Cycle Sheffield response to the proposed redevelopment of Charter Square

Furnival Gate going east

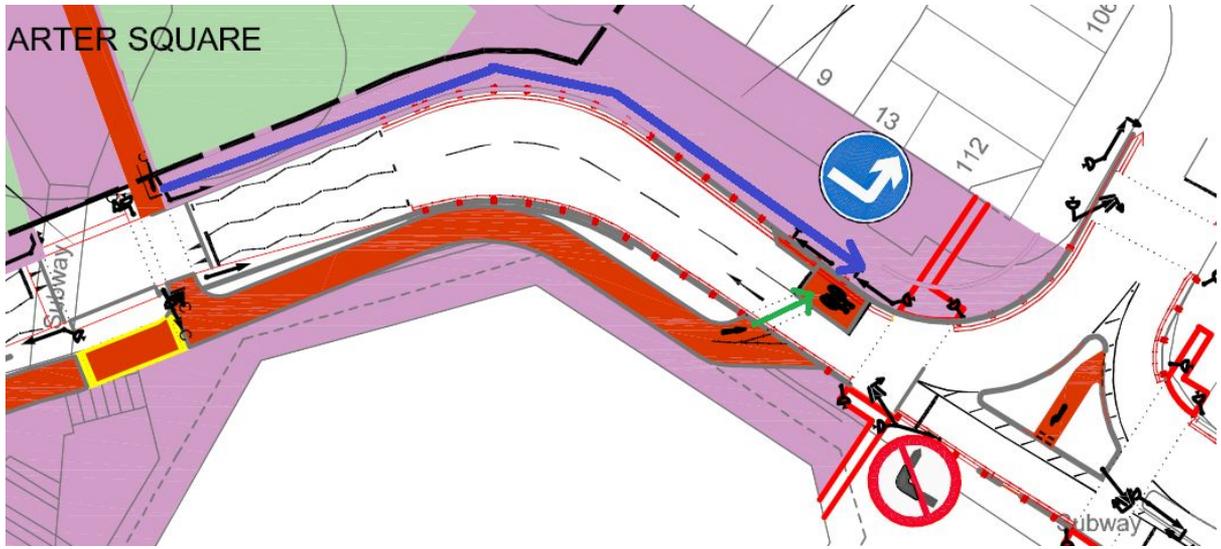
People cycling east along Furnival Gate will have to cross into the ASL box on the other side of the road and then go up Pinstone Street (see map below, green arrow). This is very poorly designed. All motor traffic going to the John Lewis car park will be travelling east along this road and buses will be travelling west. It will therefore be difficult to get into the ASL. Drivers will not be expecting people on bikes to enter the ASL from this direction. It would make far more sense to have an off road cycle path on the northern side of Furnival Gate going at least from the cycle path on Charter Square into an enlarged ASL box (blue arrow, map below). Ideally the entire junction should be redesigned.

Charter Square cycle path joining Wellington Street

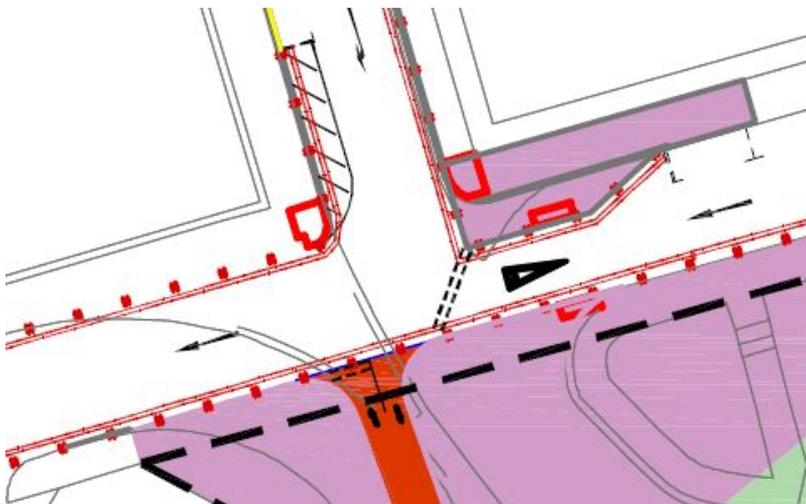
This is very poor. Wellington Street and Carver Street will be very busy with traffic going to/from the John Lewis and Wellington Street car parks. What safe or convenient route is there for people on bikes being taken north into this traffic and why would people on bikes going south be needing to enter the Charter Square development from this area, given the likely unsuitability of these access roads for cycling? If people cycling are going to be directed here then a segregated route along Wellington Street is required, and another down Carver Street joining Charter Square.

Charter Row / Rockingham Street junction going north

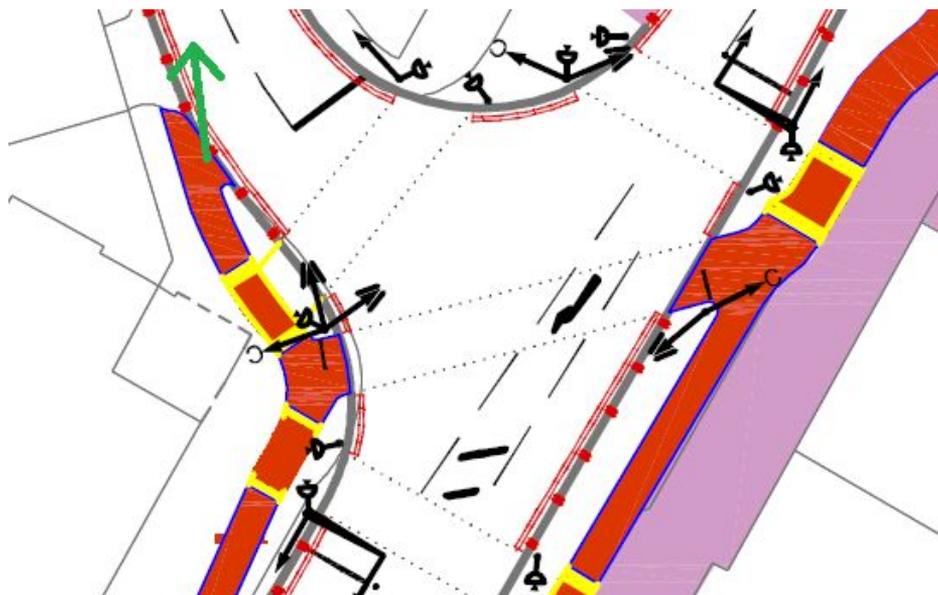
A brief section of segregated cycle path along Charter Row leads people cycling north onto Rockingham Street (green arrow, map below). This road will be busy with motor traffic going to the car parks. A segregated route up Rockingham Street is needed.

Charter Row going south

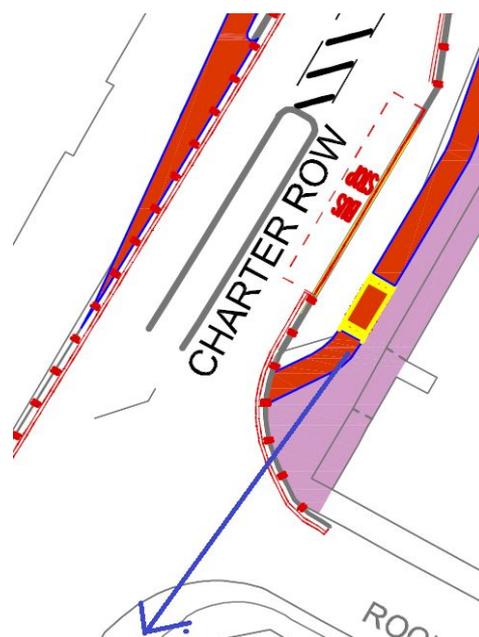
The segregated cycle route going south leads people cycling onto Charter Row just before the Rockingham Gate junction and just after a bus stop. This will be hazardous. The road will be busy with traffic from the car parks and buses will obscure the view.

The segregated route will ultimately need to continue all the way to St Mary's Gate roundabout, however at the very least the segregated route needs to be extended so that it crosses Rockingham Gate *with priority over the side road* (see map below, blue arrow) and then joins Charter Row.

Charter Square cycle path width

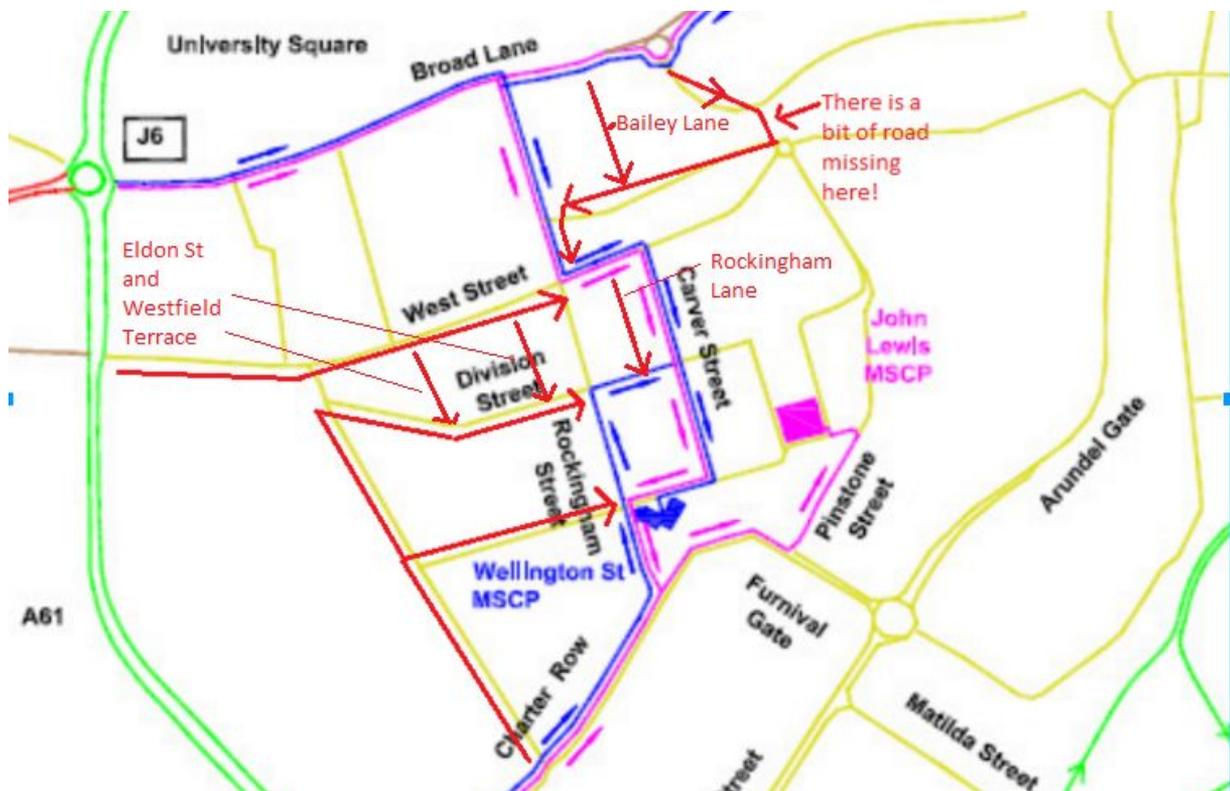
Design shows two-way cycle path through Charter Square as 2.5m wide, it needs to be at least 3m wide.
